8.1 List of Validation Studies and Proposals

Following the Checkpoint Presentation, and after rating the ideas, the VE team analyzed several validation studies and prepared several specific proposals.

The following pages contain the validations and proposals studied along with As Designed cost and VE Proposal cost. The results were presented to MDOT on Thursday, March 18, 2004. For the attendance list and copy of the presentation see Appendix C.

Exhibit V1.10
As Designed alignments with VE ramp names.

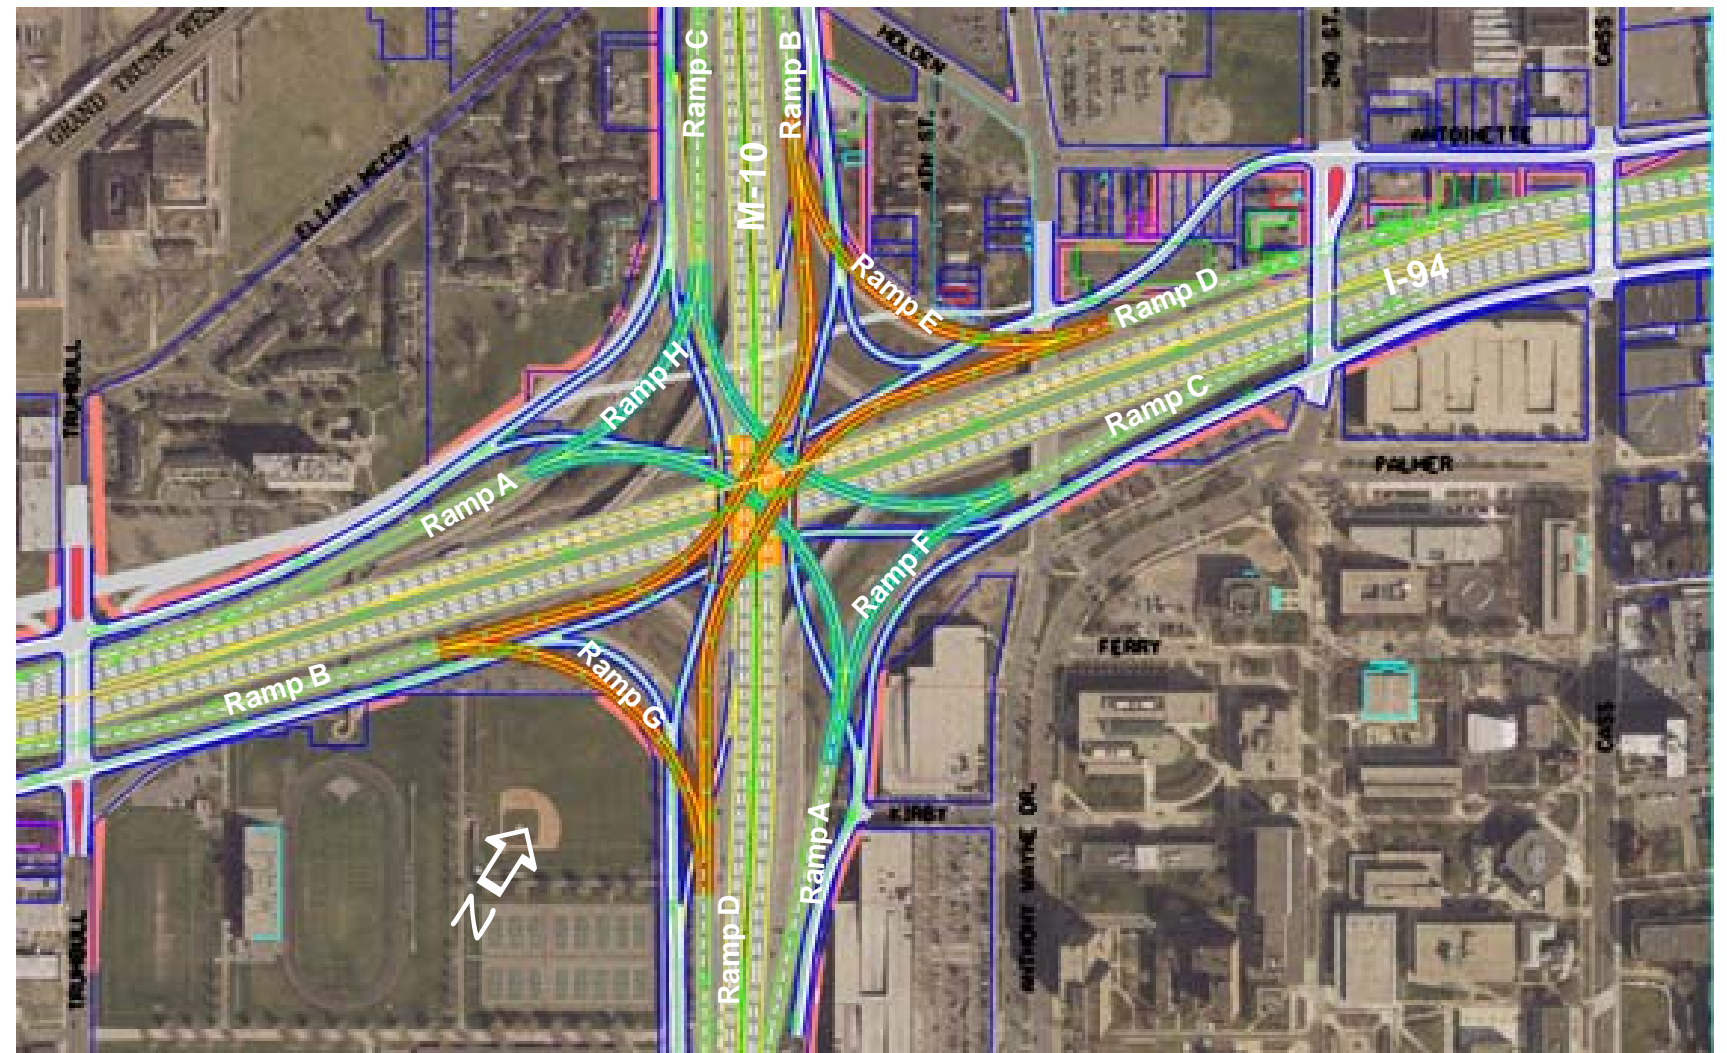
The design speed for the service drives is 30 mph. The minimum radius with a normal crown (2 percent cross slope) is 250 ft. All proposed alignments provide at least the minimum except the WB to NB service drive connection (Ramp E), which has a radius of 150 ft. This radius will provide for 25 mph with a 2.5 percent cross slope.

The southbound and westbound service drives, as designed, encroach into the McCoy Apartment green space in the NW quadrant. Some minor additional right-of-way take from the green space may be possible but is not desirable.

The clearance from the NB to EB service drive to the existing parking garage north of Kirby is approximately 12 ft. from the edge of pavement to the building corner. The proposed I-94 right-of-way can be within one foot of the building structure without violating current zoning ordinances. The remaining 11 ft. is adequate for curb and gutter, sidewalk and signing. Since Ramp F adjacent to the northbound to southbound service drive is on structure, the alignment of the service drive could be moved to the west to increase the clearance at the tightest location if necessary.

The existing 4th Street neighborhood in the NE quadrant is a critical area. Ramp E (WB I-94 to NB M-10), as designed, comes very close to the south end of existing 4th Street. An existing street right-of-way on the south side of the neighborhood lies between the homes and the proposed Ramp E. Ramp E will be on structure through this area to clear the WB and NB service drives.

Exhibit V5.1
Staging Alternative 1

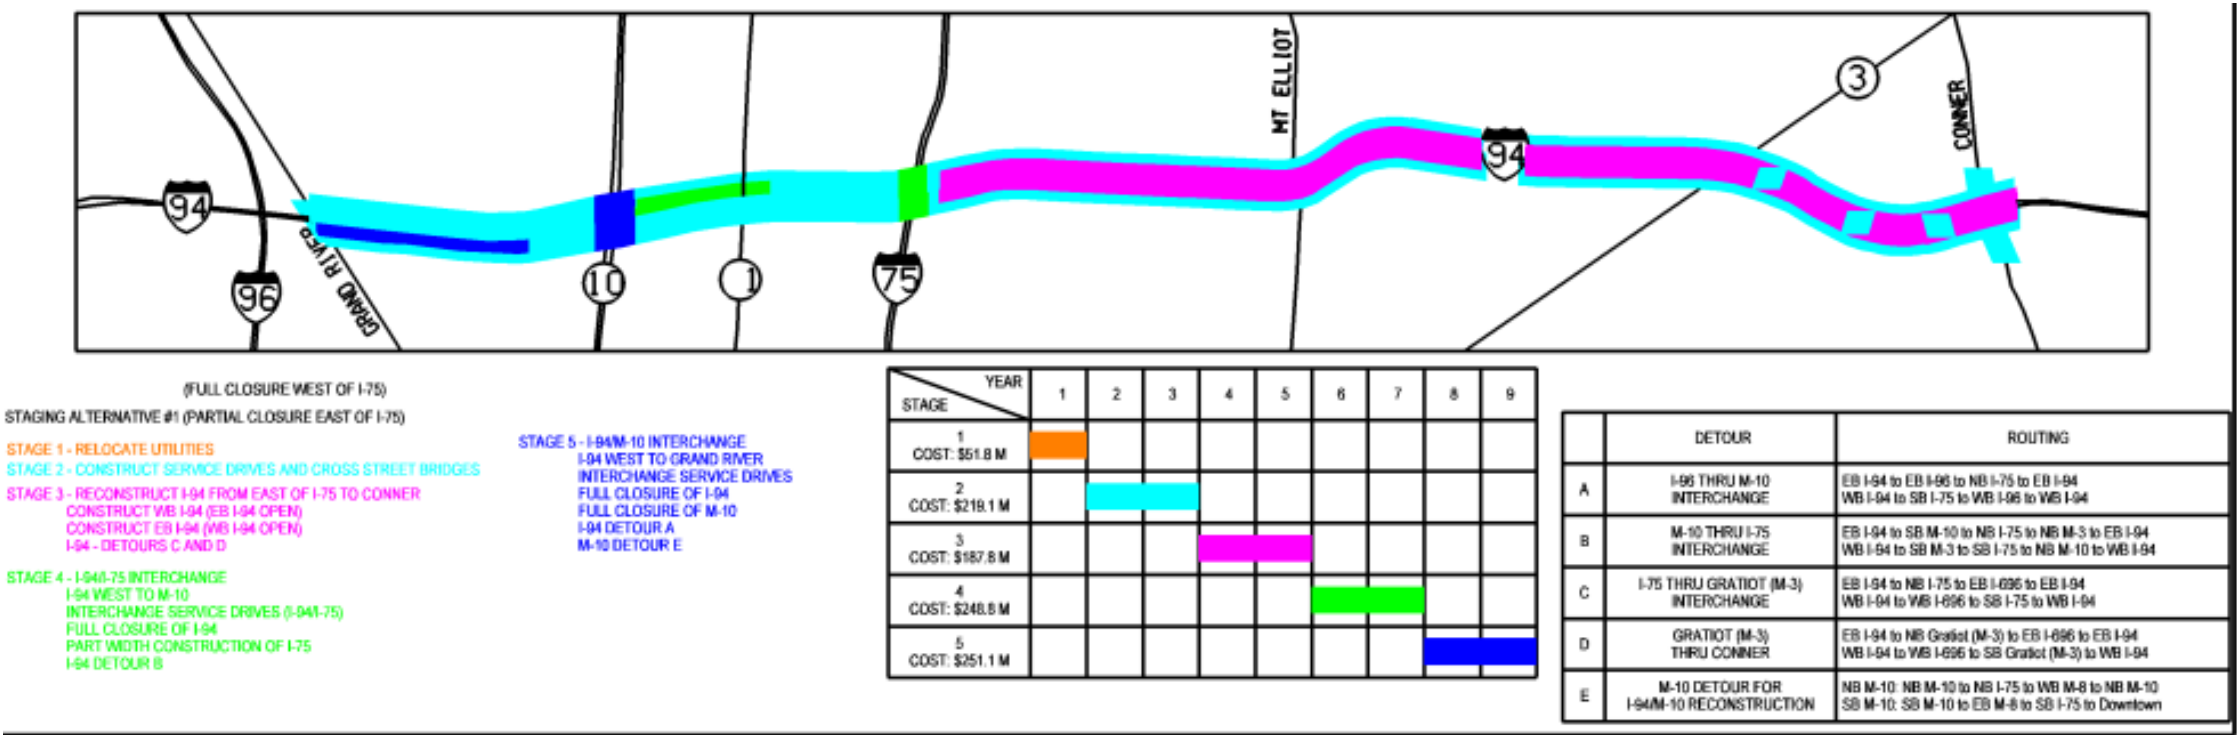
Exhibit V5.1 graphically depicts the order of work progression.

Exhibit V5.2
Staging Alternative 2

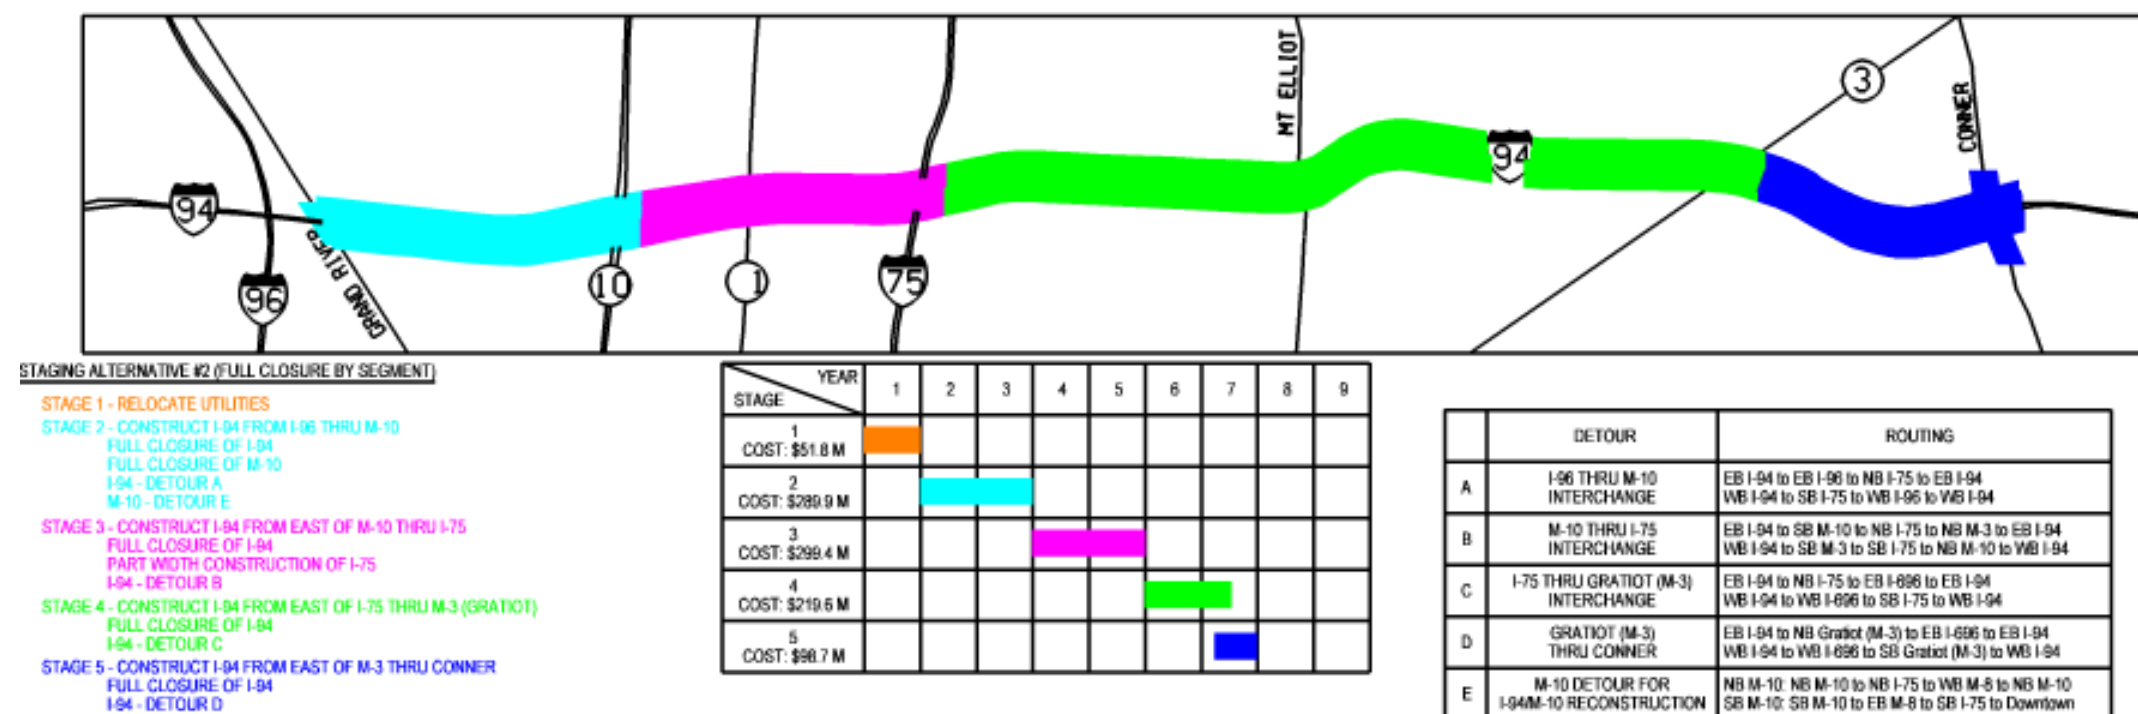
Exhibit V5.2 graphically depicts the order of work progression.

Exhibit V5.3
Staging Alternative 3

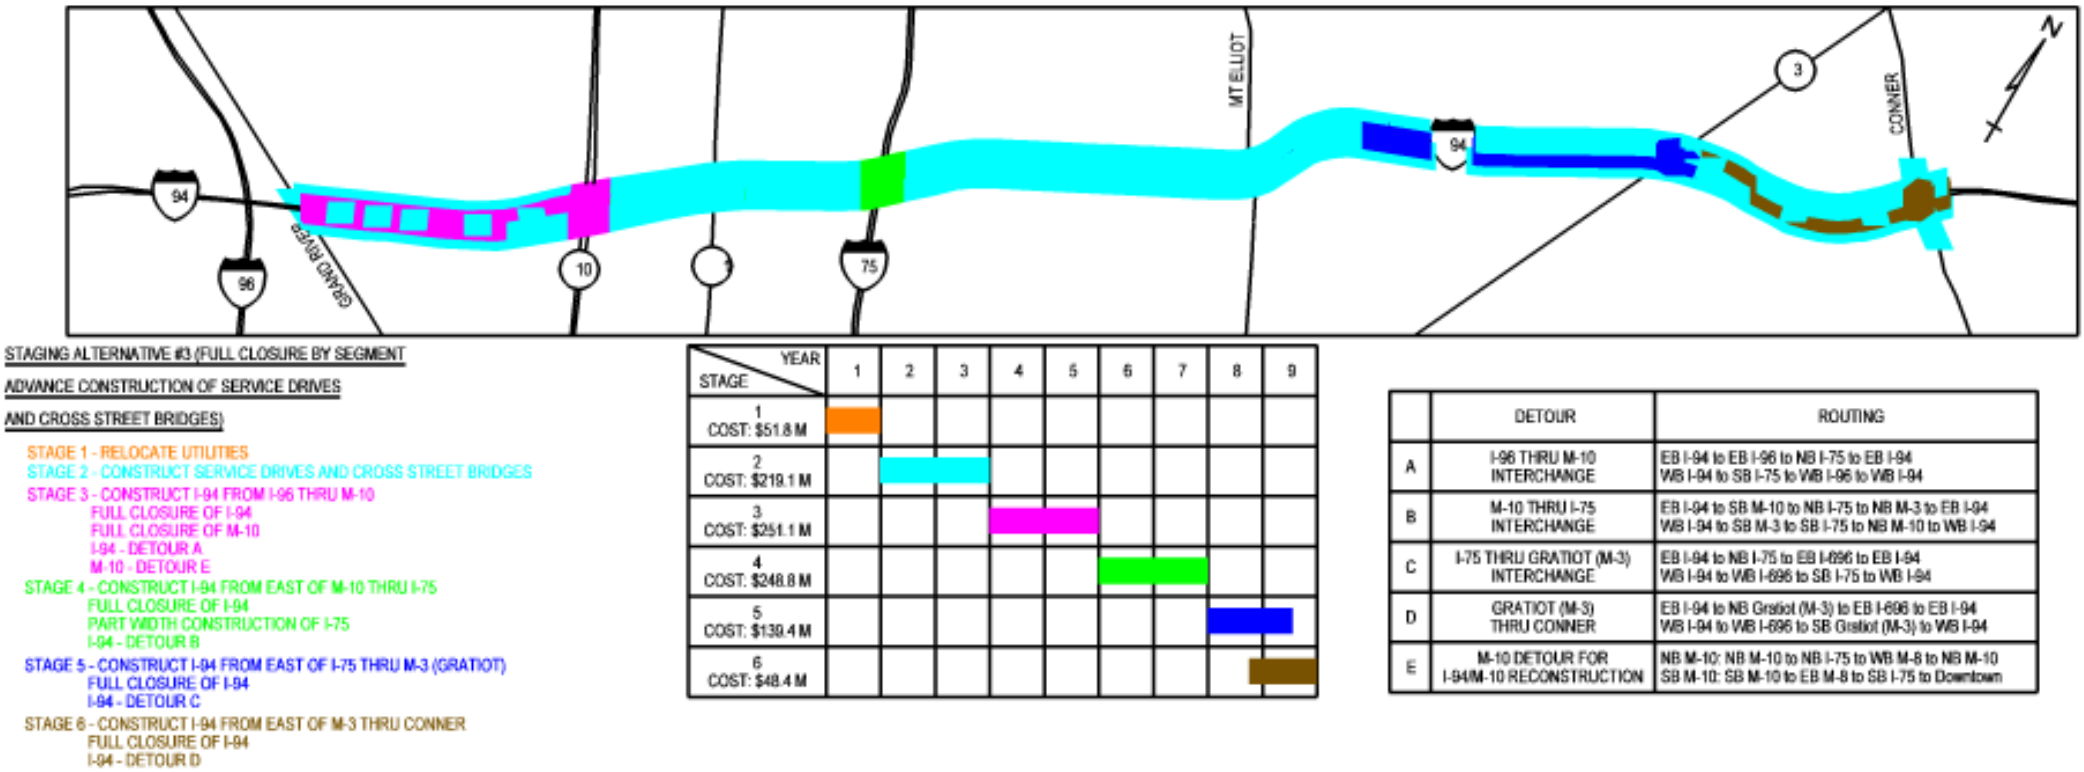
Exhibit V5.3 depicts graphically the order of the work progression.

Exhibit P2.1

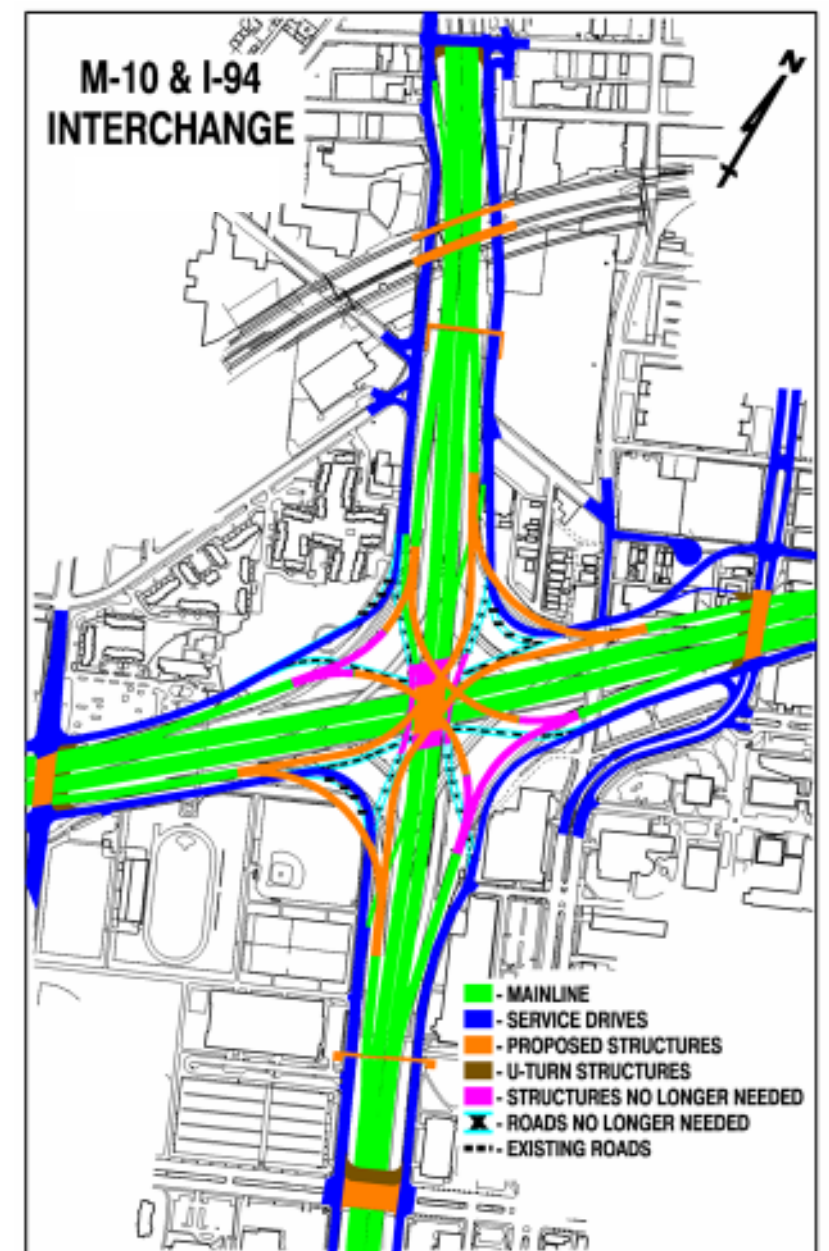
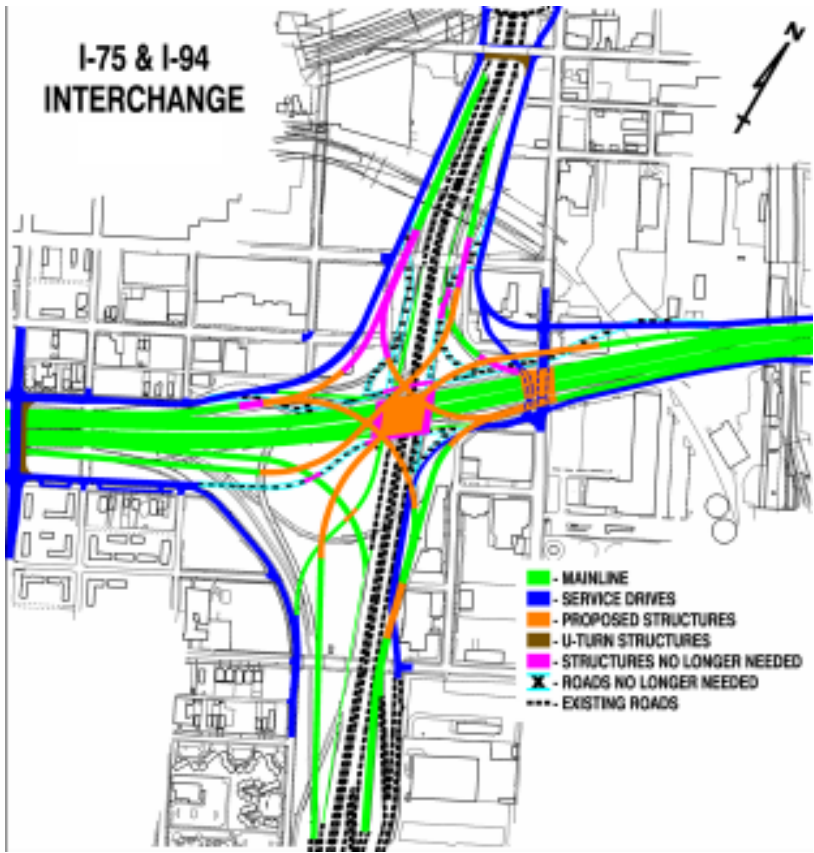
The VE proposal would keep all aspects of the “As-Designed” Proposal except for the removal of the service drives within the system interchange cores (at M-10 and I-75).

Advantages of the proposal include a substantial cost savings since less roadways and bridges would be constructed. Since interchanges would be less complex without these interwoven roadways and bridges, there would be greater potential for the interchange designs being able to meet minimum or desired design standards. Additionally, construction sequencing and maintenance of traffic considerations will be more simple. There is a greater amount of travel for motorists desiring to drive to the other side of a system interchange; however, this indirection is minor. To reduce travel times on the perimeter service drives, it is proposed to add U-turn roadways and/or bridges at the next available grade-separation. Typically, the “next” grade separated crossing is only 1/3 mile from the middle of the interchange core. As such, the

travel indirection is minor. Therefore, the VE Proposal is still considered to possess all of the advantages that the continuous service drives provide, except to a slightly less degree.

Exhibit P3.4
VE Profiles

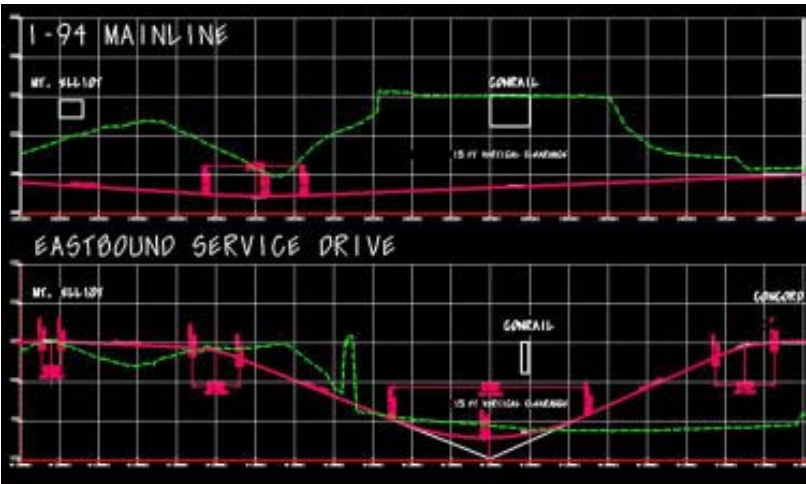
The conclusion is that the geometry of all movements can be accommodated assuming an eight foot deep railroad structure. Further design refinements during the engineering report phase may further reduce the overall amount of retaining wall required while eliminating impacts to the existing wall. The pavement elevations will also be further refined to minimize the overall lowering of I-94 in this area. The service drive curves were designed using a 25 mph design speed but the values were above the minimum K values to provide for rider comfort.

The geometry is satisfied for all movements. The Sherwood Road intersection will be either closed or a portion of Sherwood Avenue will be reconstructed to lower the roadway. This is a design refinement that is recommended to be considered during the next phase.

Exhibit P5.3
DETAIL OF PROPOSED MEDIAN EB & WB I-94

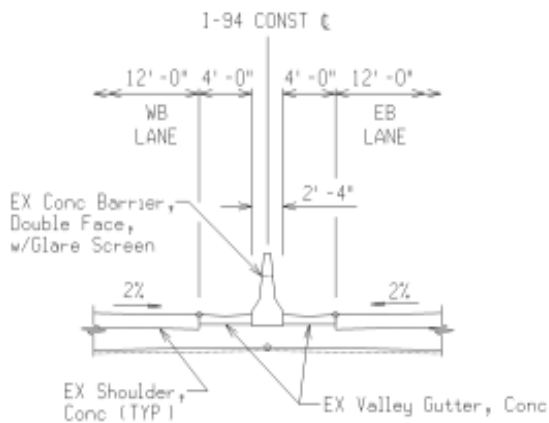
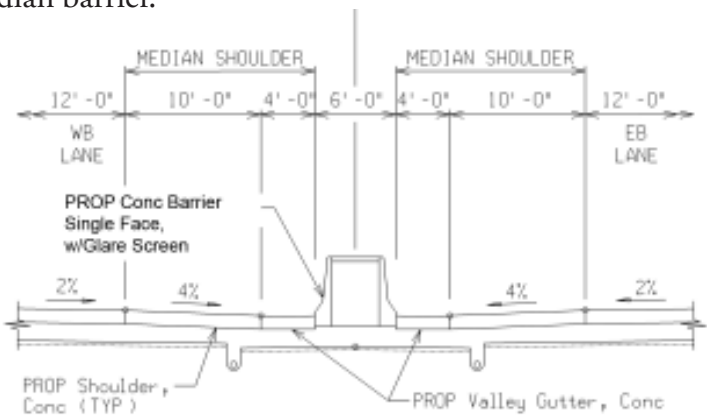
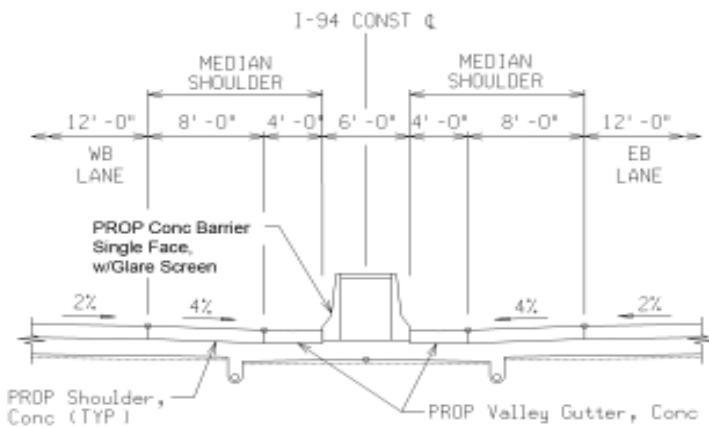
The current DEIS exhibits illustrate, and the design criteria call for a 14'-0" shoulder (12 ft. plus 2 ft. shy distance). Within the 14 ft. shoulder there will be a 4'-0" valley gutter. EB and WB I-94 will be separately by a 6'-0" concrete median barrier.

As per MDOT/AASHTO standards for a four-lane freeway section, the required median shoulder width is 12 ft. due to the high truck volume. The proposal is to construct the 12'-0" median shoulder. The 12'-0" median shoulder would be an 8'-0" shoulder and a 4'-0" valley gutter. The cost of the VE proposal is:

Shoulder:	
2 x 37,500 ft. x 8 ft. x \$3.40/sft. =	\$2,040,000
Valley Gutter:	
2 x 37,500 ft. x \$7.65/ft. =	\$ 573,750
	\$2,613,750

Additional savings are achieved in the structures, which will have shorter spans. Those savings are \$1,498,000.
